ADDENDUM NO. 3

Date: August 21, 2023

Issued by: Sacramento City Unified School District

Project: **Project #: 0510-465**
0510-465 CKM/Fern Bacon/Matsuyama/Parkway/Rosa Parks and Sutterville
Security Improvements: Group 2

SHEET NO.
C2.1

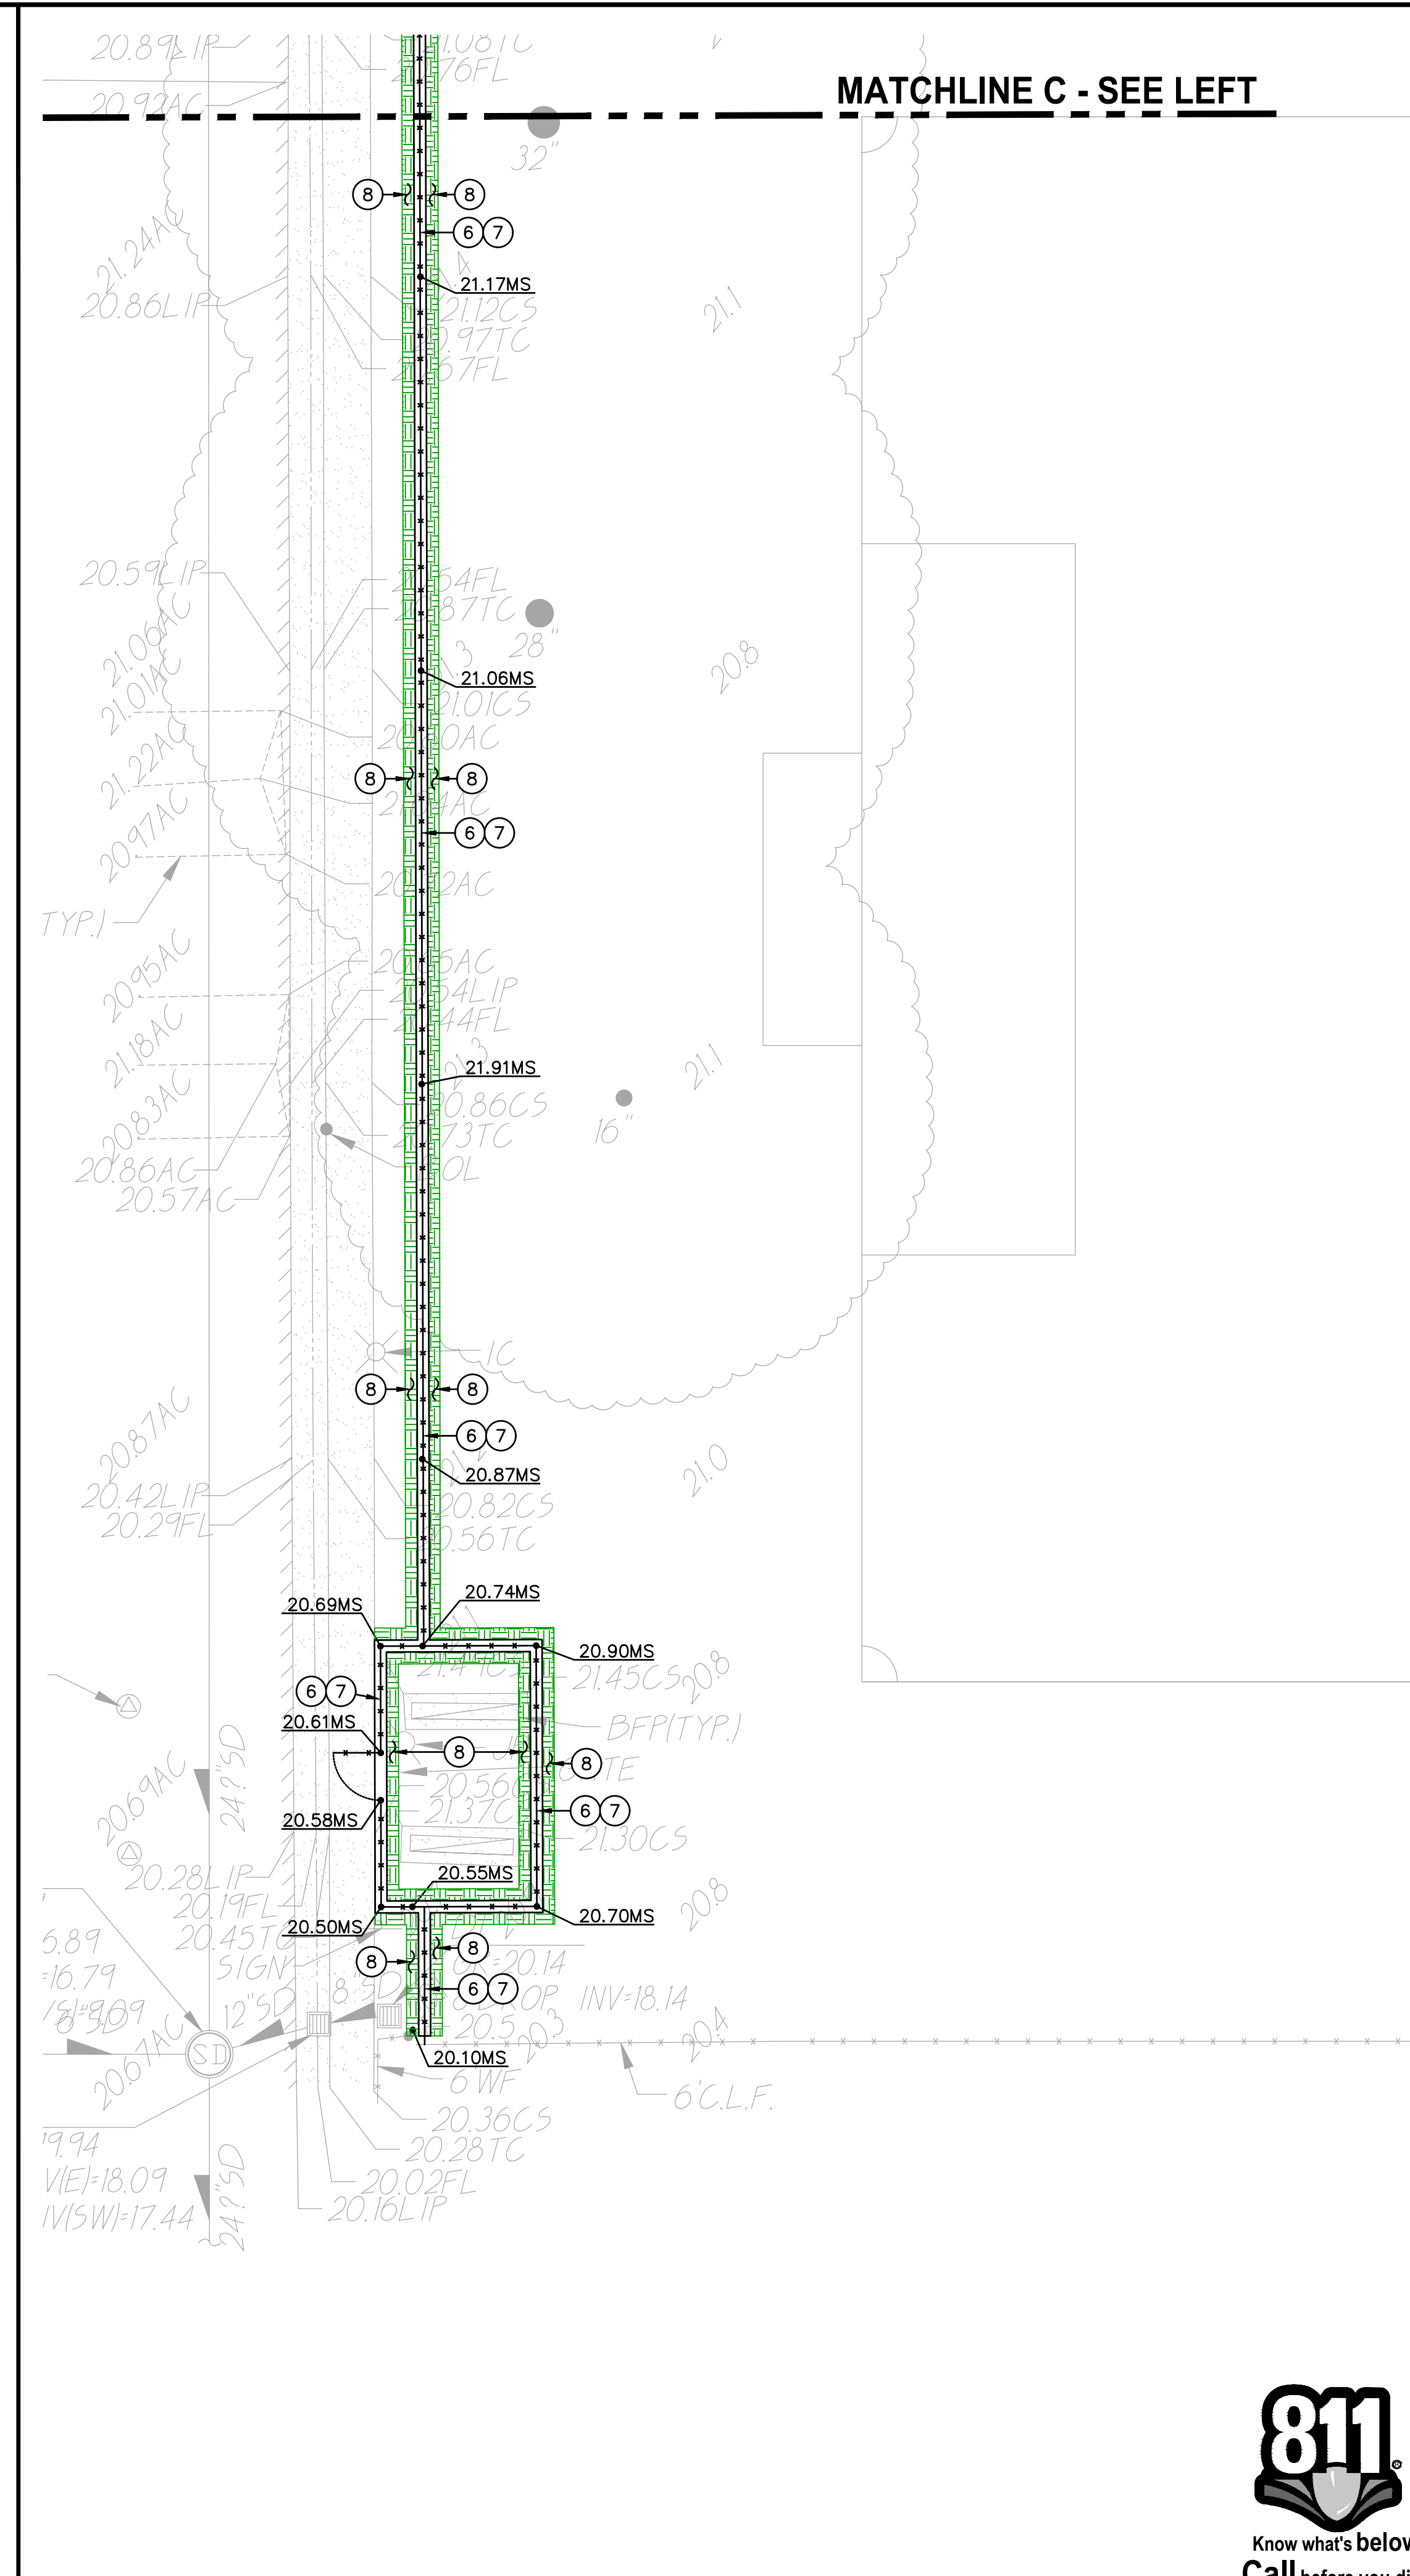
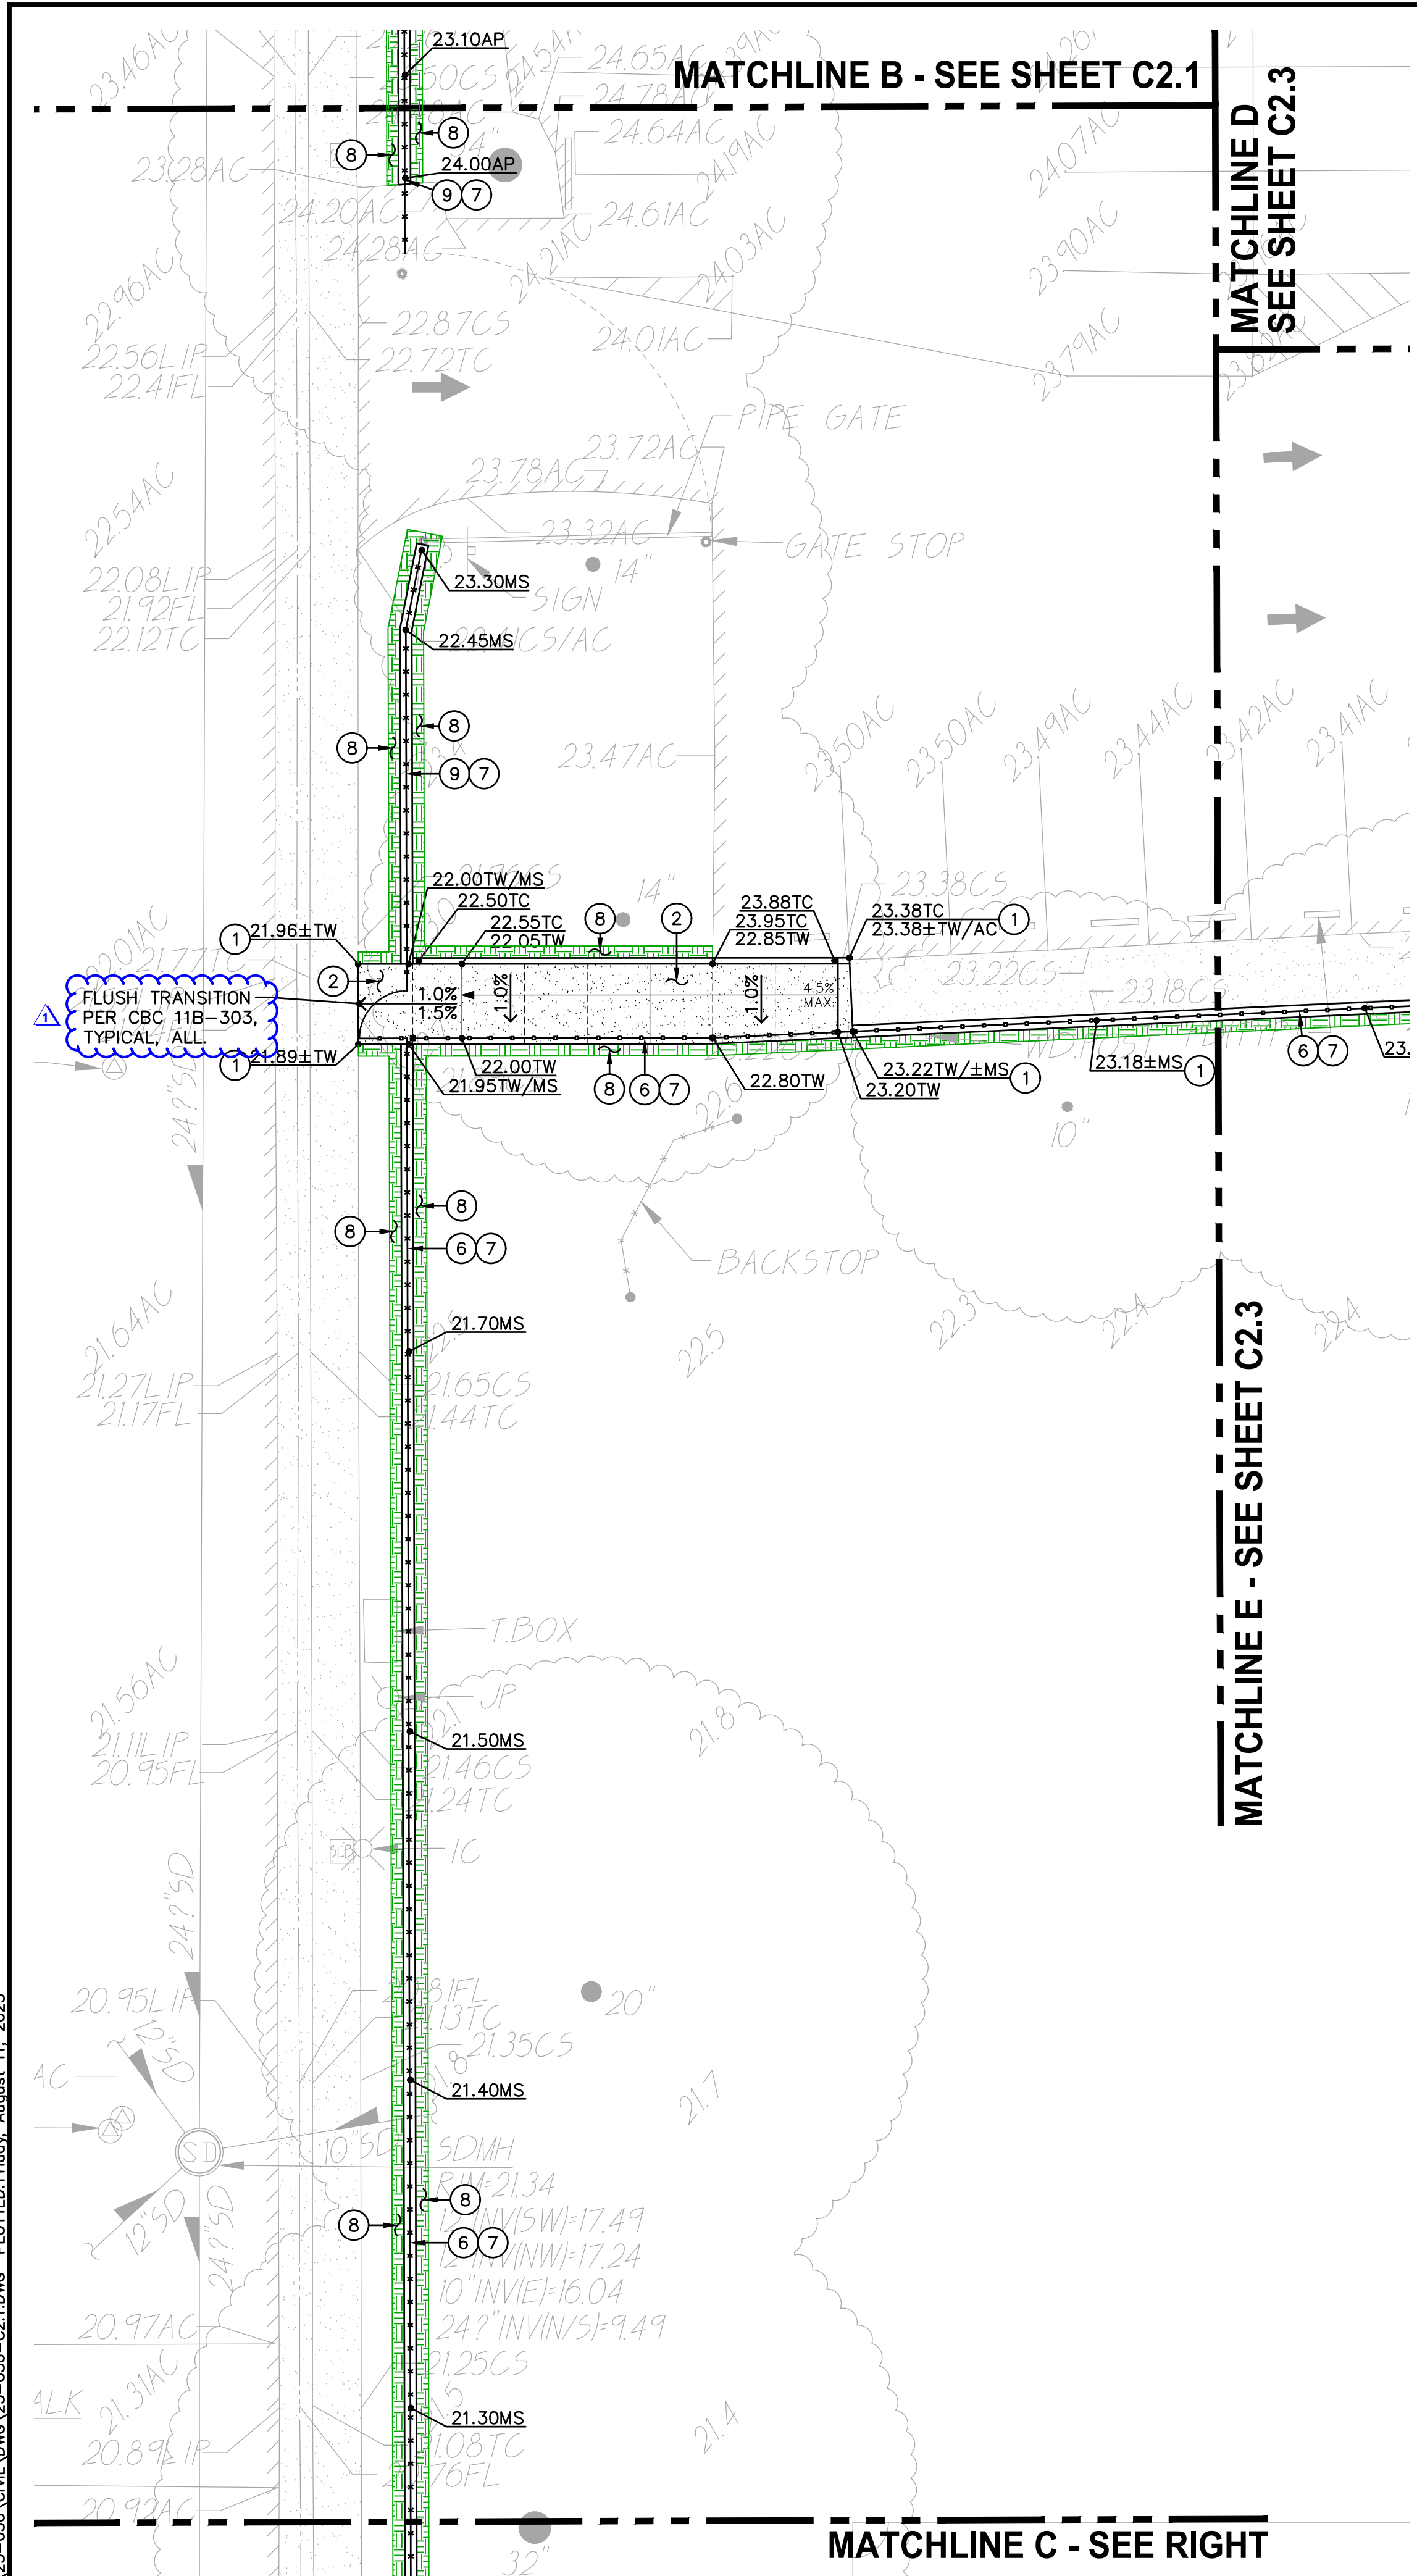
Sheet C2.1

- Additional flatwork paving shown at main entrance gate in view 1.
- Surface repair general note added.

SHEET NO.
T200

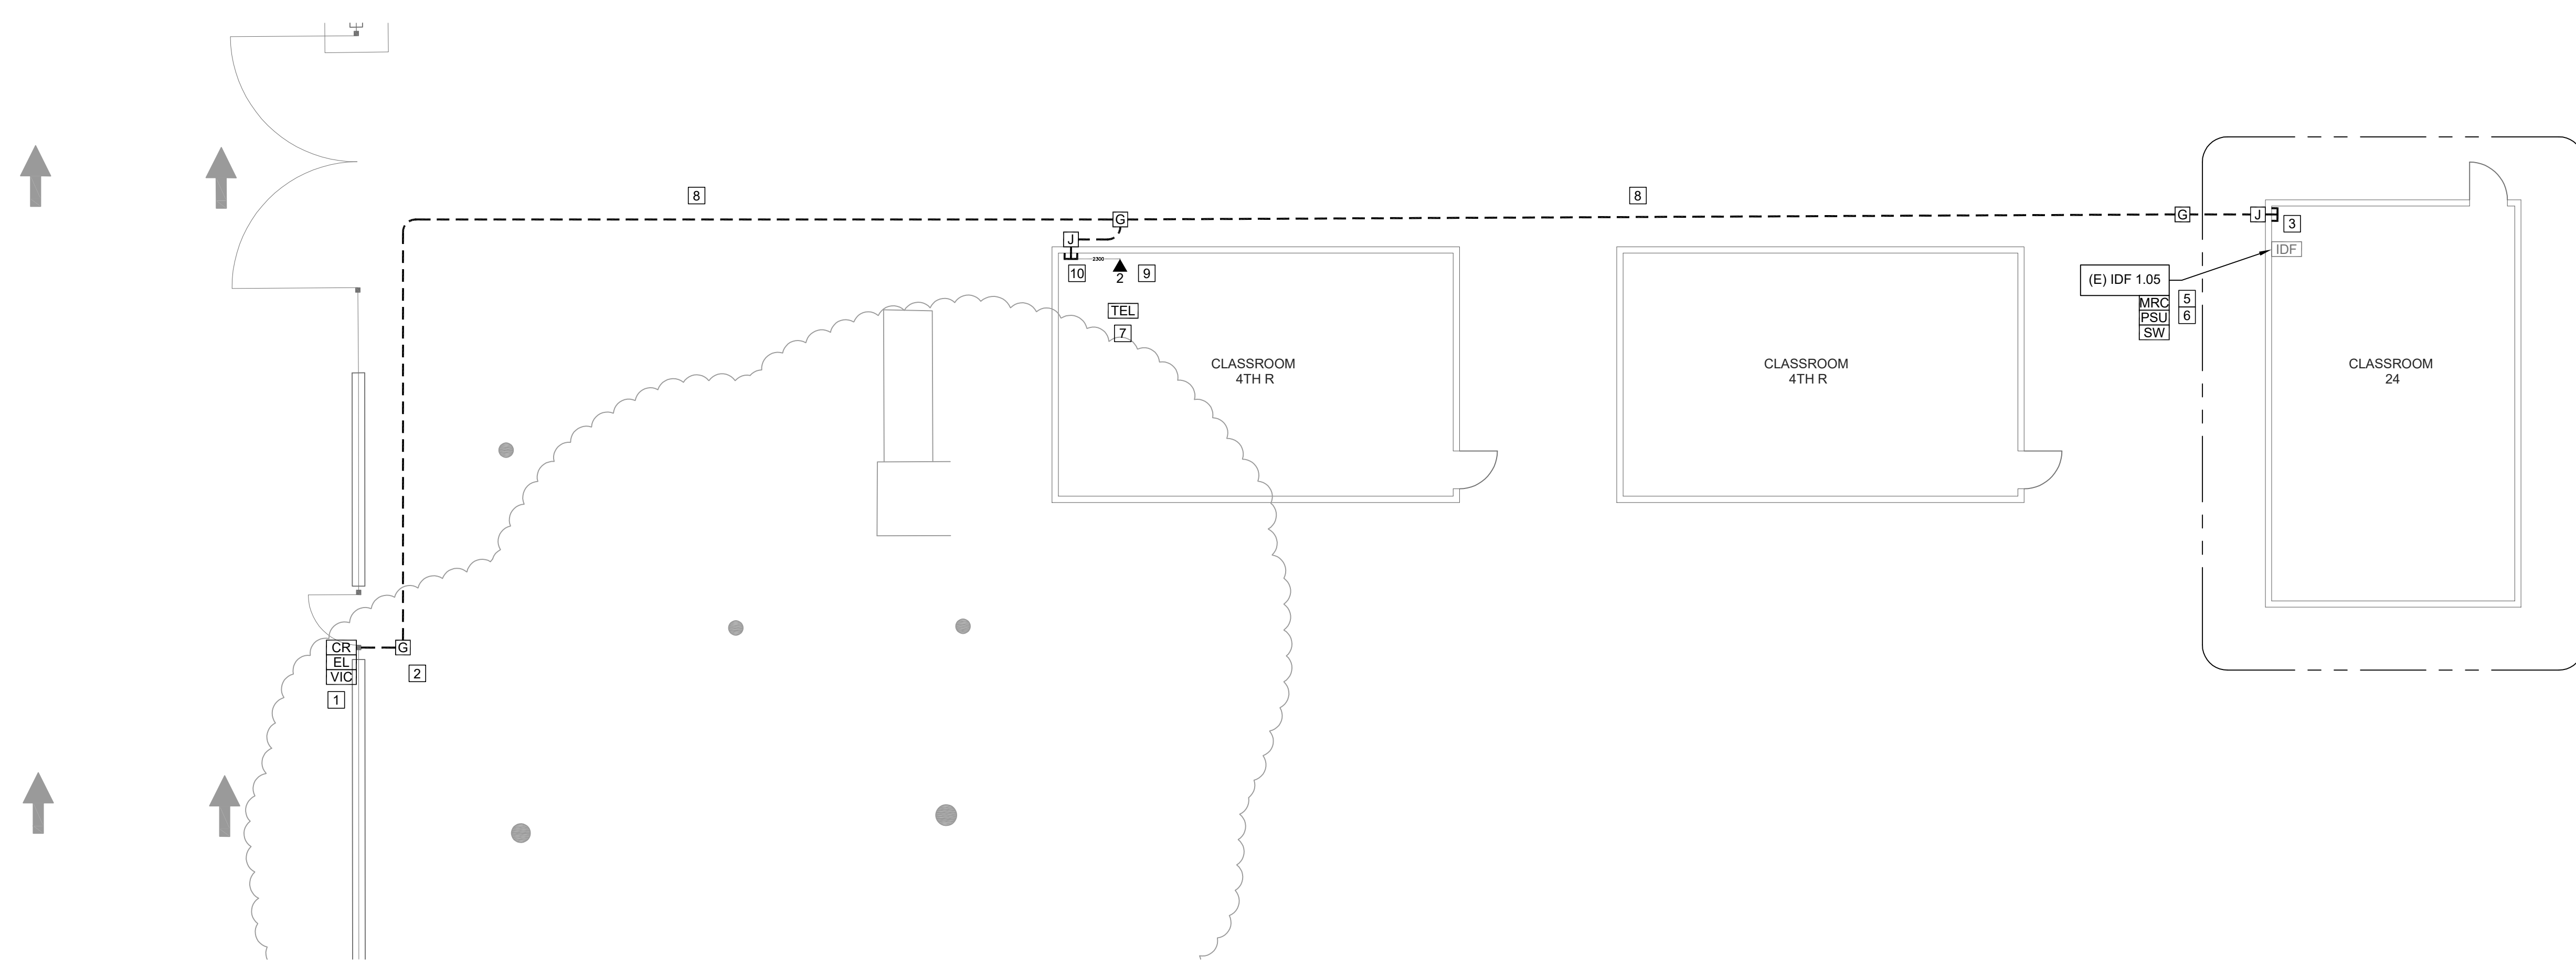
Sheet T200

- Sheet updated to include additional equipment changes and pathway routing.
